India Meteorological Department, Ministry of Earth Sciences, GoI

DGM-HQ-23011(10)/2/2024-NWP-DGM(E-43377)

Sub: Minutes of the Pre-bid meeting of the “for procuring High Performing Computing System (HPCS) for the IMD’s Operational Work” (as per RFP document) held on 20/08/2025.

IMD HPCS Data Center Proposed Layout**Instructions:**

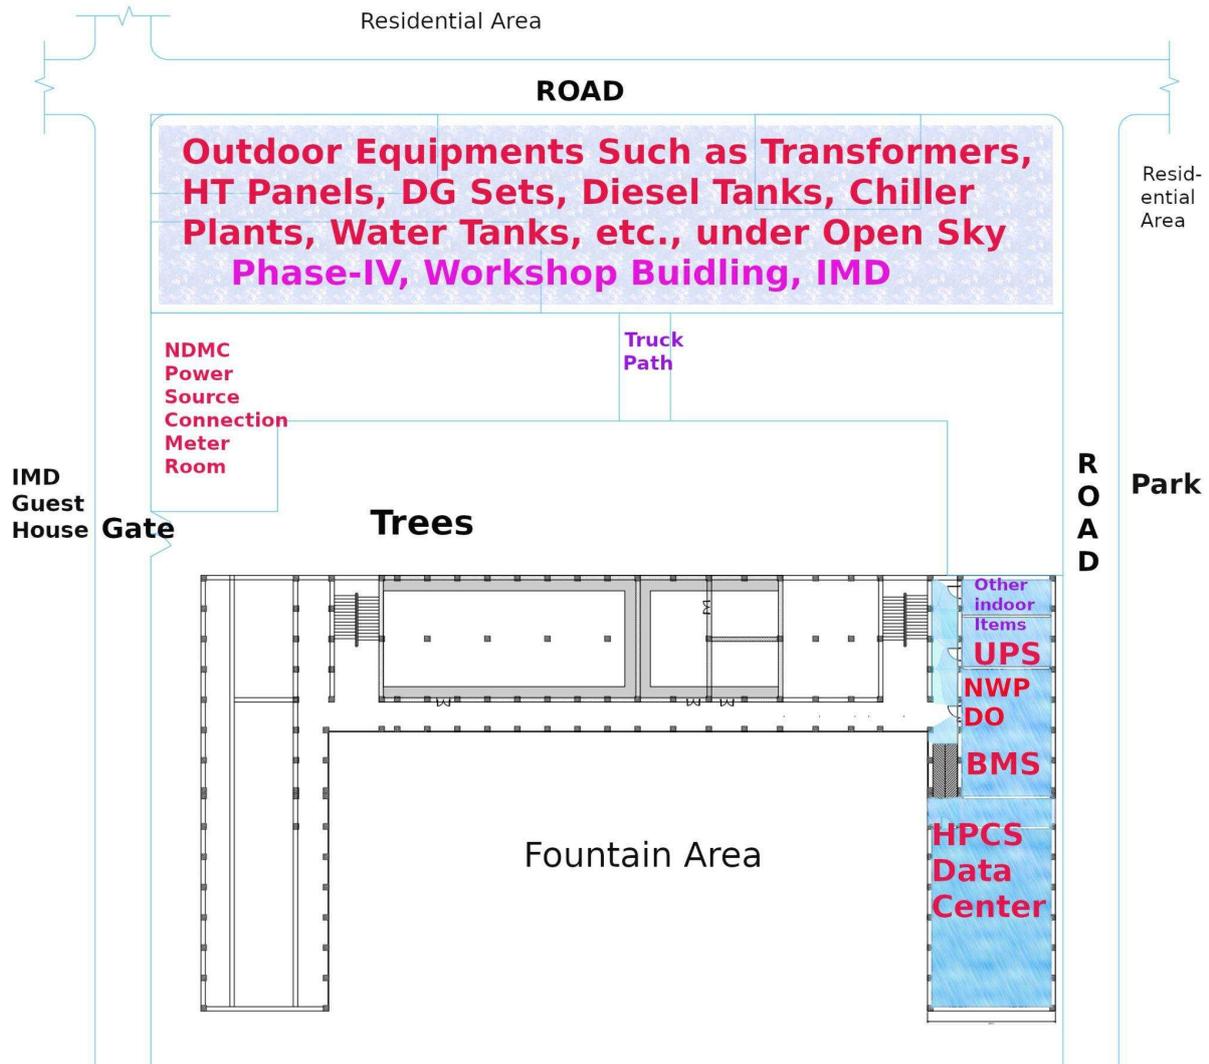
(A) RFP PAGE 122 - Appendix-3

6		General	Please provide the site location/ area drawings	Please refer to Minutes of Prebid Meeting Sr. No. (A) of General Queries
7		General	NOC,SOC & Seating arrangement required for Scientist, operators.	Please refer to Minutes of Prebid Meeting Sr. No. (C.i) of General Queries. Also, refer to 4.4(c) at RFP Page 128.
8		General	Connectivity to grid, overall plans & drawings.	Vendor has to provide all connectivity diagrams from the location of the termination of raw power as per paras 2.1.3 (a) & 2.1.3 (e) of Section VI, at page no 119. Also, refer to Minutes of Prebid Meeting Sr. No. (A) of General Queries
M/s Dell India Pvt Ltd				
1	NDA for Bechmarking		Requesting IMD that Dell will collect the benchmarking data once the NDA is signed and consume the same on CPU OEMs cluster infrastructure to run and complete the benchmarks as per RFP.	All bechmark runs have to be made by the bidder as per RFP. The formal arrangment / back-to-back NDA with the CPU OEM need to be submitted to IMD. The updated NDA has been shared with the respective HPCS OEMs on 21.08.2025.

The proposed Layout diagram of the site location is attached as **Annexure-1** of the Minutes of Prebid Meeting/Corrigendum report.

1. All Black Colored Text within the above Layout represents existing locations.
2. All Non-Black Colored Text represents proposed work and its locations/rooms/area.
3. Trees should not be cut/removed.
4. Removal of any walls and expansion of the HPCS DC area, indoor & outdoor painting, polishing, etc., are under the bidder's scope.
5. The bidder should submit a detailed layout along with the dimensions of the rooms, with the details of the planned location on the ground floor of the above-mentioned building for the data center, including indoor and outdoor equipment.
